# Preparation Support for Lelystad Airport Consultation

Report for LVNL

<b>Document title</b>	Preparation Support for Lelystad Airport Consultation Report for LVNL
<b>Author</b>	Helios
<b>Produced by</b>	Helios 29 Hercules Way Aerospace Boulevard - AeroPark Farnborough Hampshire GU14 6UU
<b>Produced for</b>	LVNL
<b>Helios contact</b>	Alan Corner Tel: +44 1252 451 651 Fax: +44 1252 451 652 Email: Alan.Corner@askhelios.com
<b>Version</b>	V1.0
<b>Date of release</b>	06 September 2017
<b>Document reference</b>	P2386D009

In July 2017, we were contracted to provide a second opinion of the down-selected route set following the planned simulations. Overall, we are satisfied that the proposed route-set will enable the start of operations at Lelystad in 2019. The process adopted by LVNL and CLSK to design, assess and down-select the most acceptable route-set from an operational perspective is generally consistent with best practice, although might not have fully considered the impact on all other airspace users. We also understand that airspace design and associated procedures are intended to be tested during a forthcoming validation simulation, this again is accepted best practice prior

**Figure 6: Lelystad Airport TMA**

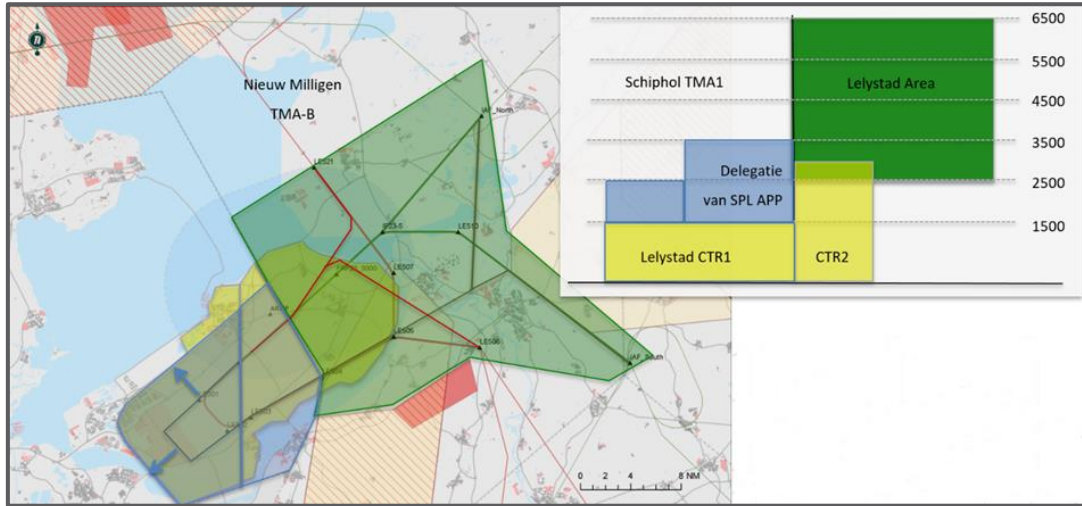
Evidently, the Lelystad airport TMA design appears to show adequate lateral containment of the Conops B+ arrival and departure routes.

**Figure 7: Vertical profiles of the arrival (green) and departure procedures (red) for Runway 05**

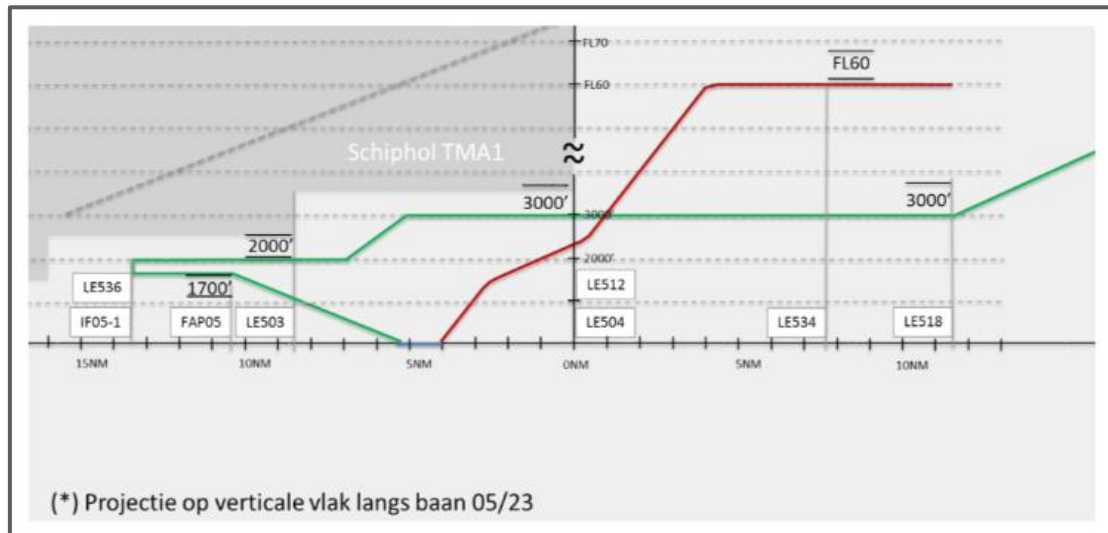
The departure procedures are shown climbing from threshold elevation to FL060 (approx. 6000ft) over a distance of approximately 11.5 NM (to waypoint LE534); this equates to a PDG of circa 8.5%. Whereas, the arrival procedure involves a series of shallow stepped descents culminating in a final uninterrupted descent from an altitude of 1700ft to threshold over a distance of approximately 6 miles; this equates to a descent gradient of circa 5.2% (3 degrees). All conceptual design gradients therefore fall within PANS OPS criteria.

**Figure 8: Vertical profiles of the arrival (green) and departure procedures (red) for Runway 23**

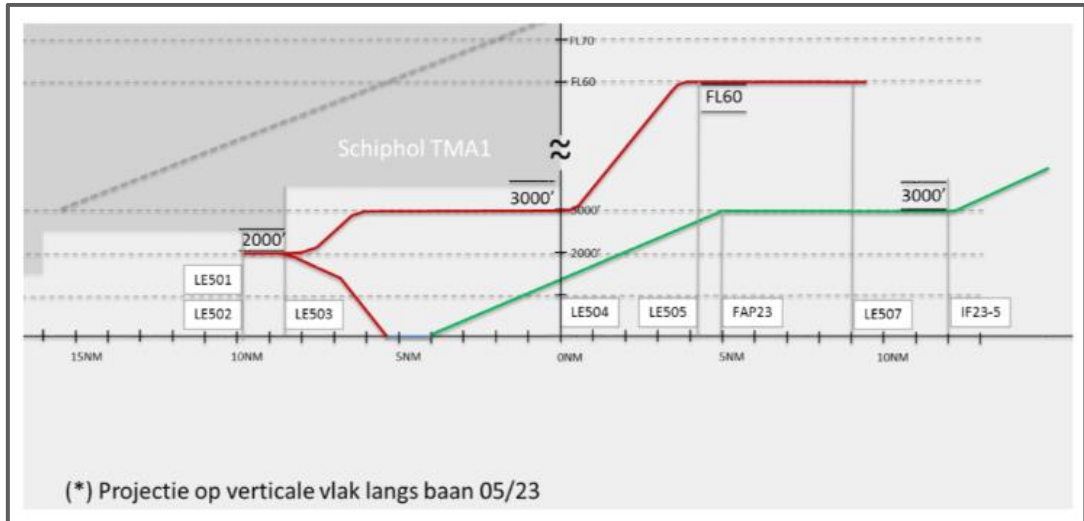
The departure procedures are shown with a series of interrupted climbing segments in order to keep departing aircraft within the stepped vertical limits of the TMA. The steepest portion involves a climb from altitude 3000ft to 6000ft over a distance of approximately 5 NM; this equates to a PDG of circa 9.9%. Whereas, the arrival procedure involves a series of shallow stepped descents culminating in a final uninterrupted descent from an altitude of 3000ft to threshold over a distance of approximately 8 NM; this equates to a descent gradient of circa 5.2% (3 degrees). All conceptual design gradients fall within PANS OPS criteria.

**Figure 9: Vertical cross section of Lelystad TMA**

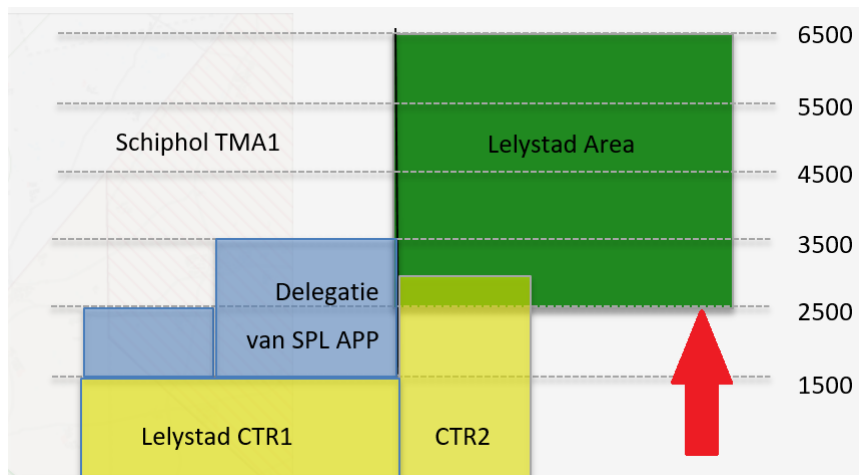
We note that whilst the Lelystad TMA achieves vertical containment of the Conops B+ routes, the base level of the Lelystad airport TMA in the vicinity of the Initial Approach Fixes at 2,500ft (as shown below in Figure 9) seems unnecessarily low, when the stated requirement is for inbounds to maintain a minimum of FL060 and to descend to 3,000ft 'as late as possible'.
